Town of Hilton Head Island

Design Review Board Meeting Tuesday, March 8, 2022 – 1:15 p.m.

PROJECT NARRATIVE FOR DESIGN REVIEW BOARD FINAL DESIGN REVIEW BOARD SUBMITTAL TOWN OF HILTON HEAD ISLAND, SOUTH CAROLINA

Project: Spanish Wells Office and Warehouse Building

EXTERIOR ELEVATIONS

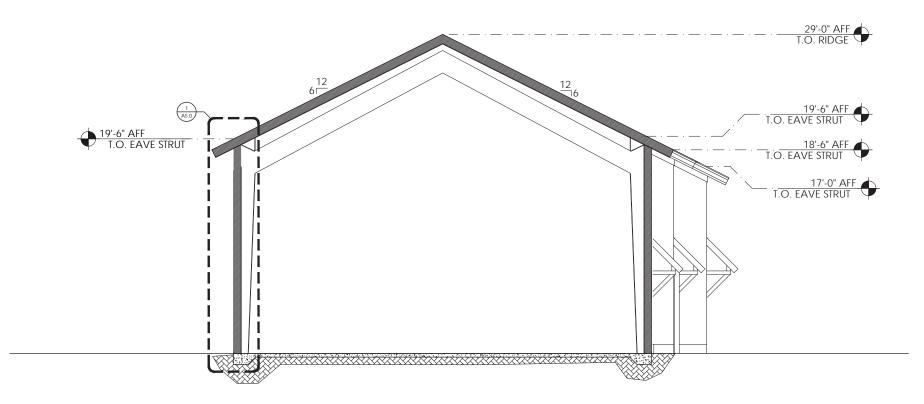
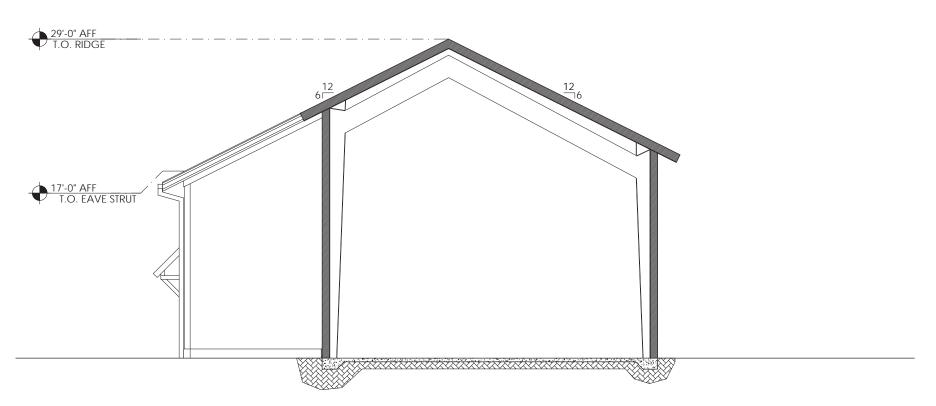
- 1. Revise the rear elevation to include more architectural detail.
 - a. Rear elevation has been changed to stucco veneer with trim to match remainder of building. Gutter and downspouts have also been added to the elevation.

- a. The gable end roof overhangs were extended to an 2'-0" overhang and the rake overhang was extended to an 1'-0".
- 6. Clarify dumpster location on the site plan and provide a screen.

DRAWING TITLE LIGHTING AND PLANTING PLAN

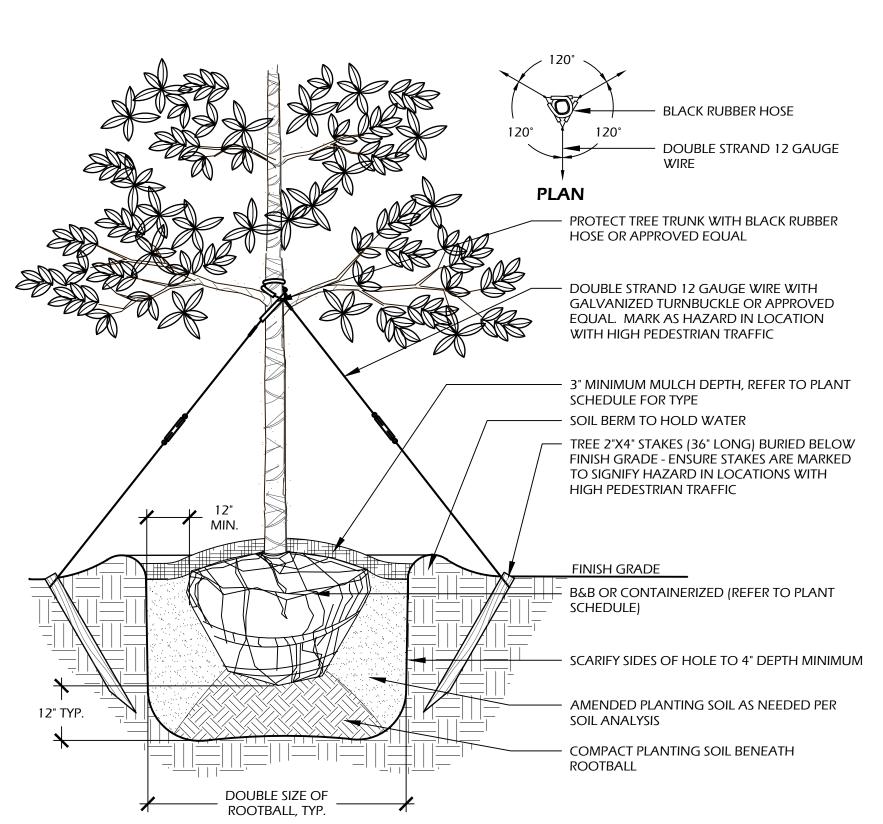
PROJECT NAME: Lucky Beach Bar + Kitche	n		DRB	#: DRB-000498-2022
DATE: 02/23/2022				
RECOMMENDATION: Approval RECOMMENDED CONDITIONS: 1. Provide a color board for DRB review. 2. Specify the color of the rope. 3. Specify the light temperature of the landse 4. Provide a specification for the bike racks.	cape lighting		conditions 🔀	Denial
ARCHITECTURAL DESIGN				
DESIGN GUIDE/LMO CRITERIA	Complies Yes	No	Not Applicable	Comments or Conditions
DESIGN GUIDE/LMO CRITERIA Utilizes natural materials and colors	_	No 🖂	Not Applicable	Comments or Conditions Specify the color of the rope in the fence.
·	_	_	Not Applicable	
Utilizes natural materials and colors Decorative lighting is limited and low wattage and adds	_		Not Applicable	Specify the color of the rope in the fence. Specify 3000K or less on the landscape lighting
Utilizes natural materials and colors Decorative lighting is limited and low wattage and adds	_		Not Applicable	Specify the color of the rope in the fence. Specify 3000K or less on the landscape lighting
